Objection to Application 2024/4982/P

Site Address: 15 Montpelier Grove, London, Camden, NW5 2XD

Description: Replacement of the existing rear conservatory with a rear extension, replacement of existing extension flat roof with pitched roof incorporating two rooflights and replacement of uPVC window on the first floor at the rear of the house with double glazed timber framed sash window.

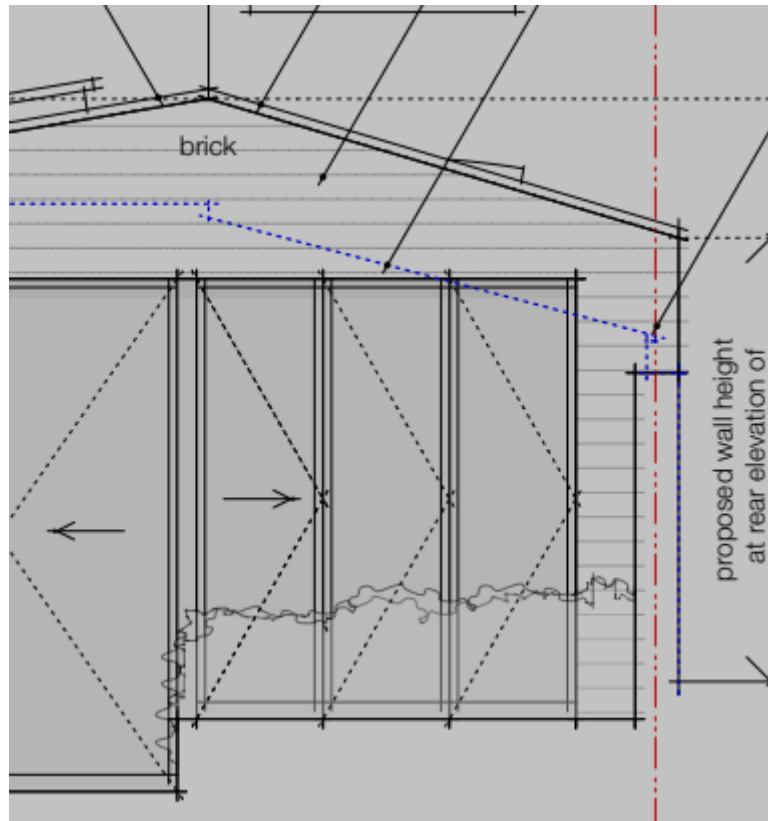
The proposal would result in further side extension of the existing rear element, as well as an increase in height of the party wall by around 0.9m, and the height of the eaves and ridge of the extension by around 0.6m.

Due to the increased height of the proposal, the rear window cornice to the rear, which is an original and attractive architectural feature would be lost almost entirely, as can be seen from the below excerpt of the elevation plan. A reduction in the height of the proposal would suitably maintain this architectural feature.

Image of Rear Facing Window serving Habitable Space:

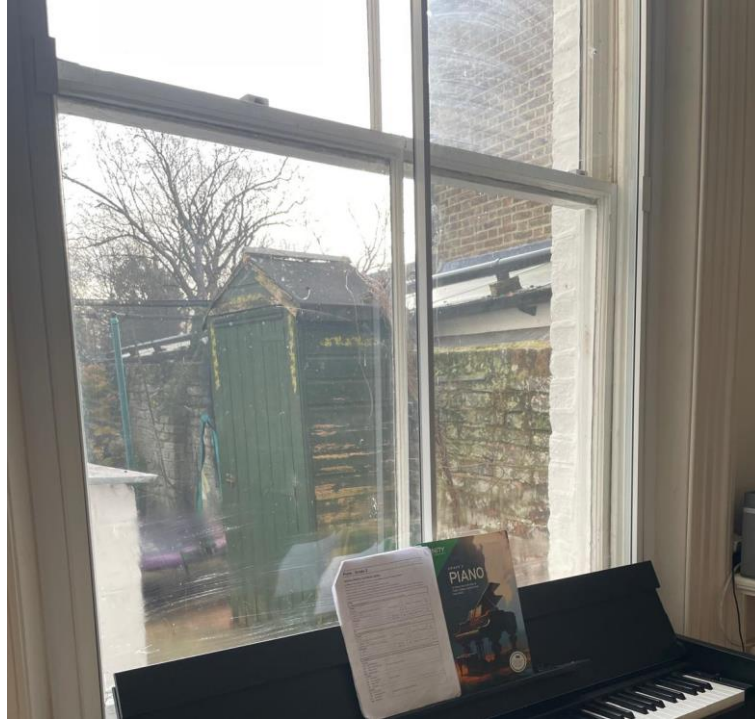
The proposal also seeks to demolish the existing conservatory, and erect a side return extension, with a significant increase in the eaves and ridge height. The extension sits within extremely close proximity to a rear-facing window of No. 14, a south facing kitchen window and and a south-facing diner bay window sitting directly across from the extension. These windows are major sources of light and outlook for the kitchen and dining room, and rear reception within; photographs from these windows are included below:

The increased height of the party wall by 0.9m and the eaves and overall ridge by 0.6m; this would result in the siting of a new tall, blank wall within extremely close proximity to these glazing features, which serve the most important habitable spaces within the dwelling. The extension would extend to over 8m in depth, directly along the boundary of the two dwellings. As can clearly be seen within the provided photographs, this would result in a significant and unacceptable enclosing and

overbearing impact on the residents of No. 14, and would remove all outlook from these windows, resulting in unacceptable residential amenity impacts.

My clients would be agreeable to an extension of the same depth as the existing addition, which does not exceed 2 metres eaves height on the boundary with No. 15 and 2.6 metres apex height (as measured from ground at 14 Montpelier Grove, which should correspond to c2.6 metres and c3.2 metres as measured from the ground at 15 Montpelier Grove due to the ground level difference of approximately 0.6m between the two houses). This is considered to be a reasonable adjustment given this is generally considered to be the maximum height of a standard boundary treatment and given the approximate ground level difference of 0.6 metres between the two houses, this would provide more than adequate internal headroom and be in line with the most recent and comparable precedent referenced at n9 Montpelier Grove, and superior to the 2.5m floor to ceiling height considered as adequate by the London Plan 2021.
